BOWDOINHAM RECYCLING CENTER

Public Meeting: 9-8-2020

Existing Building Analysis

TYPICAL SECTION ~ LOOKING AWAY FROM THE ROAD

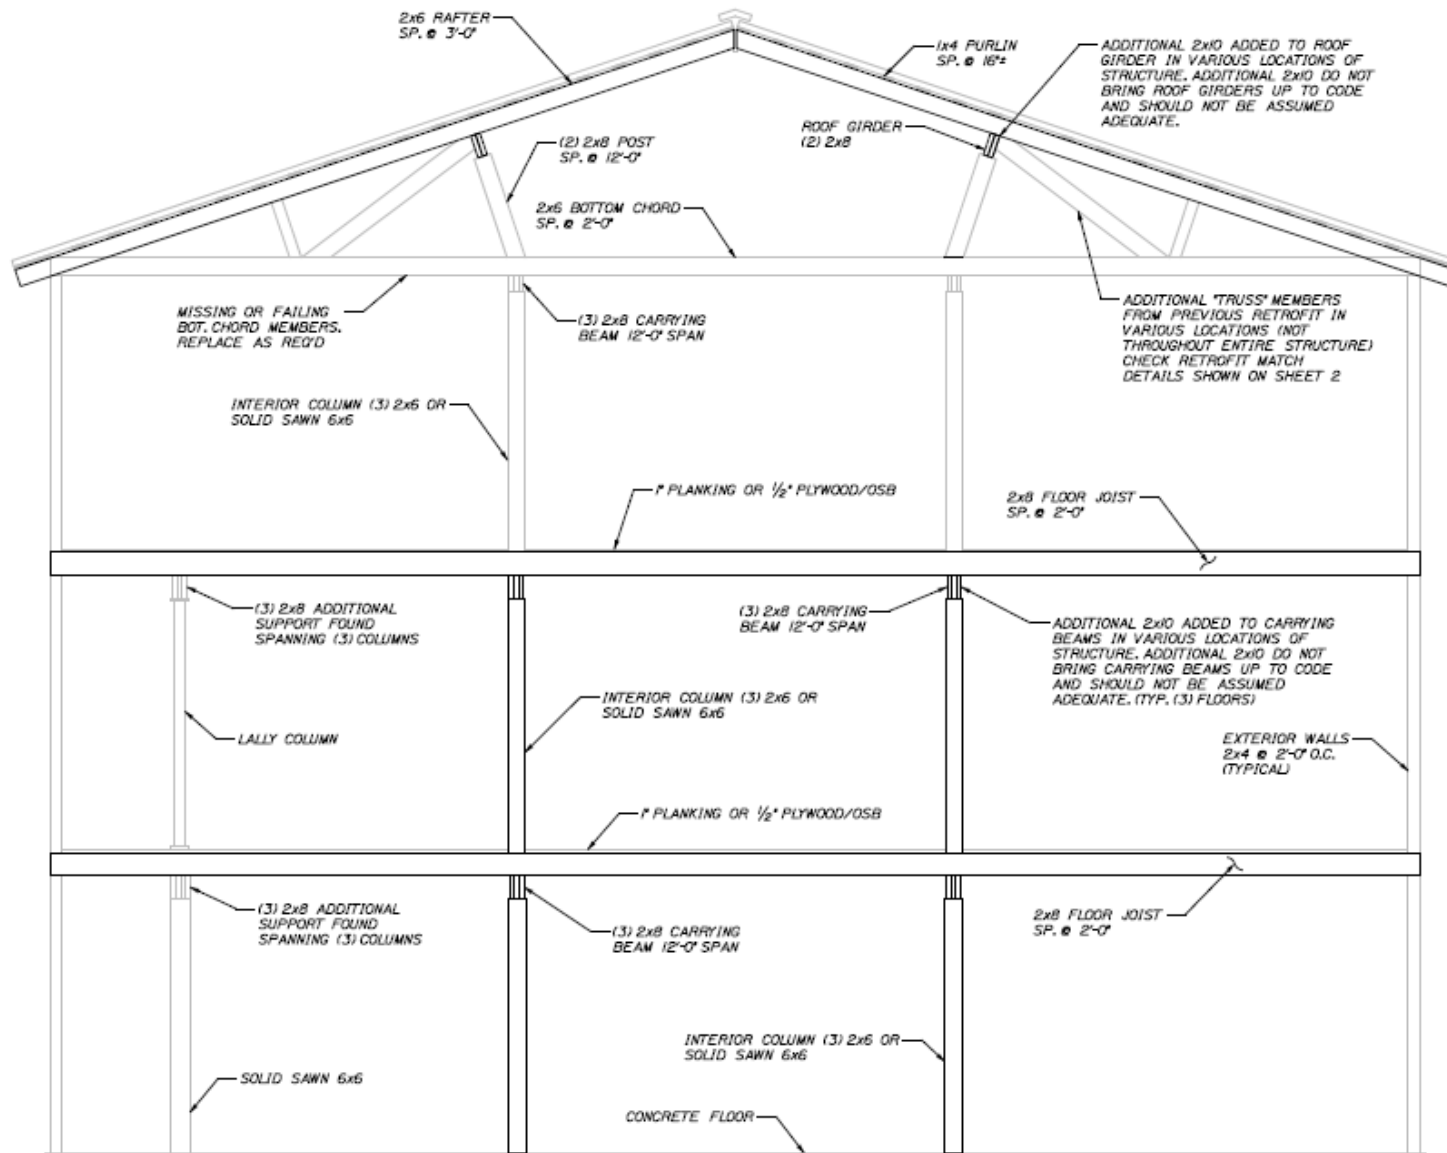
- Calderwood Engineering has previously analyzed the building in 2008 and 2013.
- 2008
 - Town requested that we determine the capacity of the existing structure
 - We determined that the existing floor is rated to carry 27.6psf
 - This is not adequate capacity for a storage area per ASCE 7 or IBC
 - This is the capacity that a crawlspace or attic would be expected to have
- 2013
 - Town requested that we develop a plan to bring the building up to code.
 - Storage Warehouse for Light Storage = 125psf
 - Existing roof members are also undersized (already a roof failure)
 - Modifications to building designed to meet this requirement

1/2" - 1'-0"
 NOTE: MEMBERS IN BOLD ARE UNDERSIZED AND NEED RETROFIT TO BE ABLE TO SUPPORT DESIGN LOADS
